Access Compliance Report

Public Rights-of-Way

(Curb Ramps)

Intersection ID: 10034403	Main Street: PIEDMONT_ROW_DR_SOUTH	Cross Street: N/A	Location: NE
ADA ID: E5F95DED6BBC	Ramp Type: PerpDiag	Initial Pass/Fail: Fail	Overall Compliance: No
		Severity Score: 8.75	
Codes/Mitigation Info/Possible Solution		Field Measurements/Component Compliance

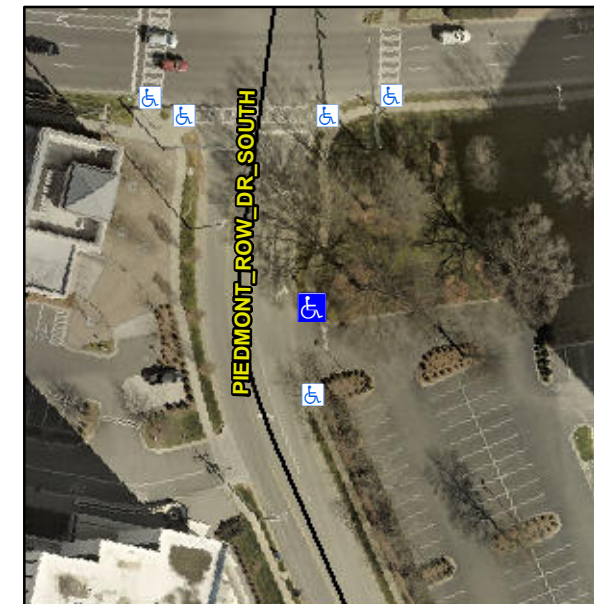
Not Found, R304.5.1

Compliance	Description	Data	Compliance	Description	Data
N/A	Ramp Length (in)	53.0	Yes	Ramp Slope (%)	6.9
No	Ramp Width (in)	46.0	Yes	Ramp XSlope (%)	1.9
N/A	Flare Type LT	N/A	N/A	Flare Type RT	N/A
N/A	Flare Slope LT (%)	N/A	N/A	Flare Slope RT (%)	N/A
N/A	Flare Traversable LT?	N/A	N/A	Flare Traversable RT?	N/A
N/A	Landing Length (in)	N/A	N/A	DWS Provided?	N/A
N/A	Landing Width (in)	N/A	N/A	DWS Contrast?	N/A
N/A	Landing Slope (%)	N/A	N/A	DWS Length (in)	N/A
N/A	Landing X Slope (%)	N/A	N/A	DWS Full Width?	N/A
N/A	Landing Curb? (Y/N)	N/A	N/A	DWS Offset (in)	N/A
N/A	Shared Landing?	N/A			
N/A	Gutter Ponding?	N/A	N/A	Gutter Slope (%)	N/A
N/A	Gutter Lip Ht (in)	N/A	N/A	Gutter X Slope (%)	N/A
N/A	Painted X Walk1?	No	N/A	Painted X Walk2?	No
	X Walk 1 Direction	To W		X Walk 2 Direction	To SW
N/A	X Walk 1 Width (in)	N/A	N/A	X Walk 2 Width (in)	N/A
	X Walk 1 Slope (%)	0.7		X Walk 2 Slope (%)	2.3
	X Walk 1 X Slope (%)	2.5		X Walk 2 X Slope (%)	0.1

Remove & Replace Curb Ramp With Two New Directional Ramps or Equivalent.
